RESPONSE TO REQUEST FOR ADDITIONAL INFORMATION

US-APWR Design Certification

RAI NO.: NO. 1044-7140 REVISION 3
SRP SECTION: 03.08.04 – Other Seismic Category I Structures
APPLICATION SECTION: 3.8.4
DATE OF RAI ISSUE: 07/08/2013

QUESTION NO. 03.08.04-55:

Figure 1. Fuel Handling Area Pits

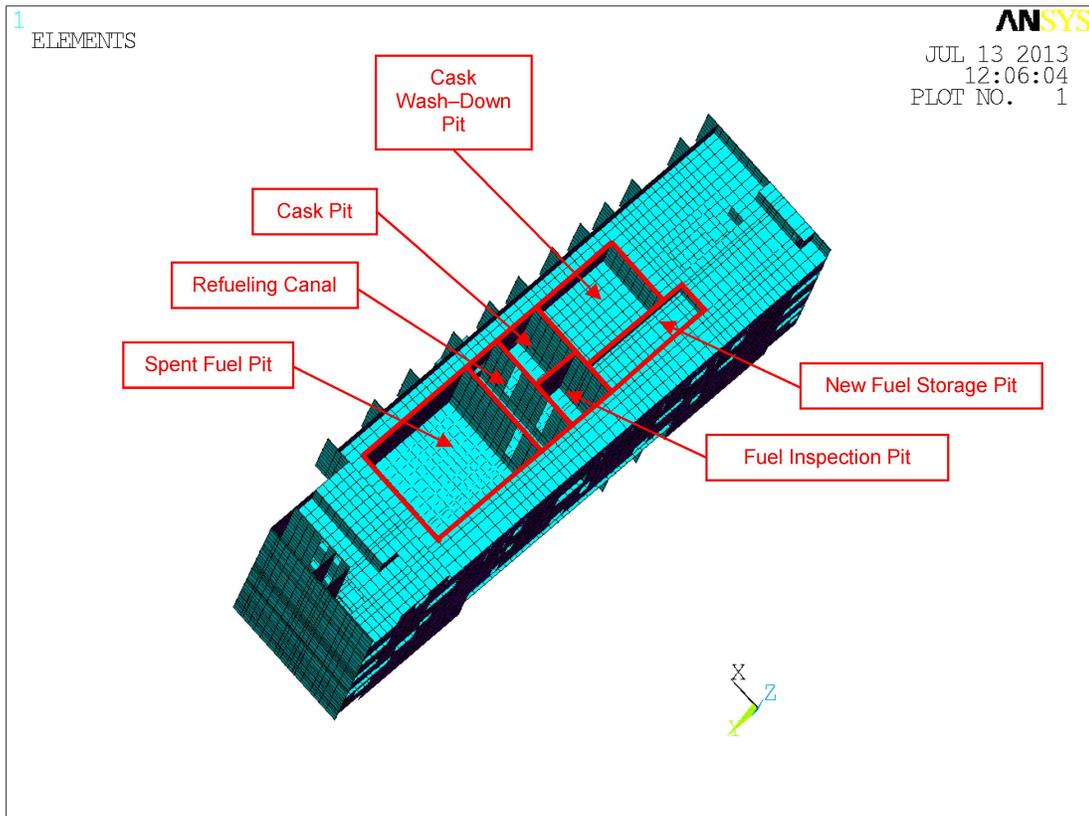
The applicant is requested to provide figures depicting the design for the areas of the fuel handling, the new and spent fuel storages, and the structural steel framing supporting system to the areas; and describe how the loads from these areas are transferred down to the basemat during an earthquake.

Loads were applied to the fuel handling area pits in the ANSYS model in two ways: (1) loads from water, and (2) loads from equipment. The water weight in the pits was applied to slabs using MASS21 elements. Static and Dynamic pressure from the water was applied to the surrounding walls of each pit. Loads from equipment inside the pits were applied by changing the density of the slab elements in the locations of those pieces of equipment. These loads include pumps, fuel storage racks (new fuel, damaged fuel, and spent fuel), structural steel to support fuel racks, spent fuel, damaged fuel, damaged fuel container, fuel transfer system, new fuel elevator, and pit gates. Figure 1 shows the layout of the fuel handling area pits in the ANSYS model.

Loads from the fuel handling area pits are transferred from the slabs to the connected shear walls. These shear walls carry the load down to the basemat during a seismic event.

The steel racks in the fuel handling area pits are made up of several individual steel framing racks. These racks have yet to be designed and will be designed in the detailed design phase. In the ANSYS model, an evenly distributed load was applied over the slab area

where all the individual steel framing racks reside. Overall seismic behavior of the several individual steel racks residing in each pit is assumed to be similar.
